**ADDENDUM NO. 3  
RAIL STREET EXTENSION AT  
MORGANTOWN INDUSTRIAL PARK TIF PHASE 6  
MORGANTOWN, WEST VIRGINIA**

**Project No:** 11-262

**Date:** October 3, 2011

**BOX CULVERT WITH WING WALL BOTH ENDS**  
 EQUAL TO OR AS PRE-FABRICATED BY CARR CONCRETE,  
 WAVERLY WW TO MEET WVDOT STANDARDS.  
 MINIMUM 8" THICK WALL WITH 7000-8000 PSI CONCRETE.  
 NOT TO SCALE

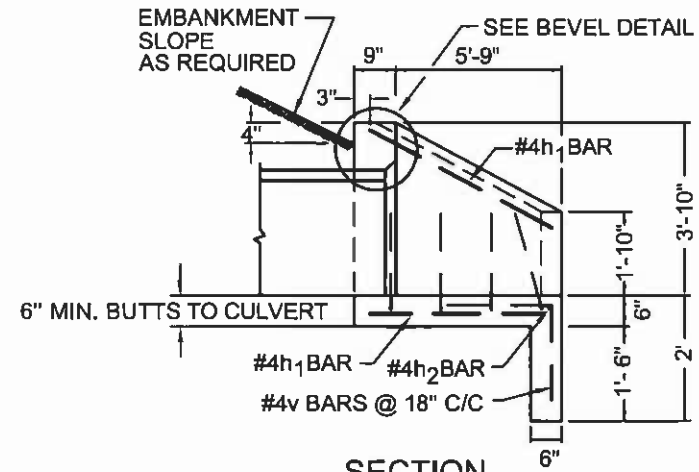
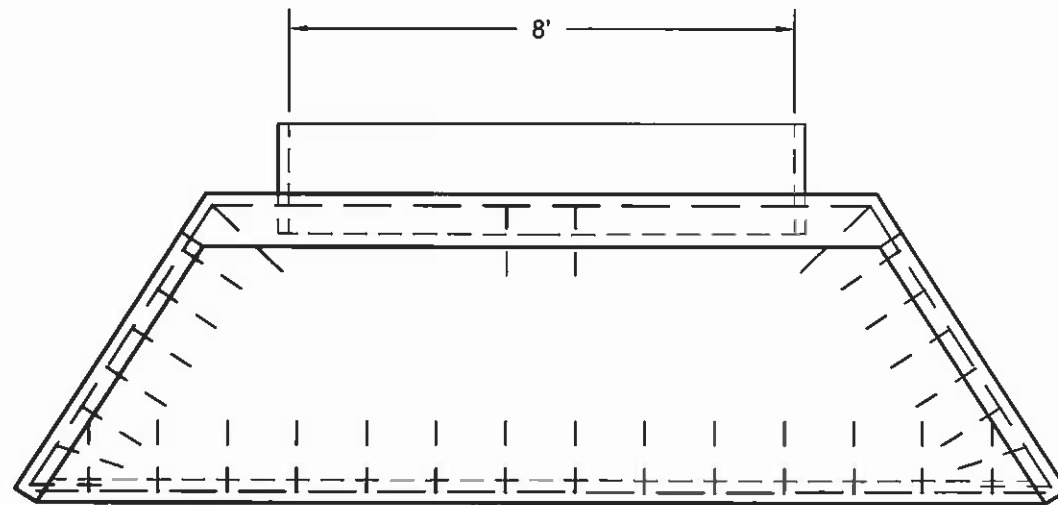
- 4' x 7' box culvert changed to 3' x 8' box culvert and detail of box culvert added to drawings.
- 125 LF of 21" diameter HDPE pipe changed to 24" diameter.
- A detail of the box culvert added to the drawings is attached.
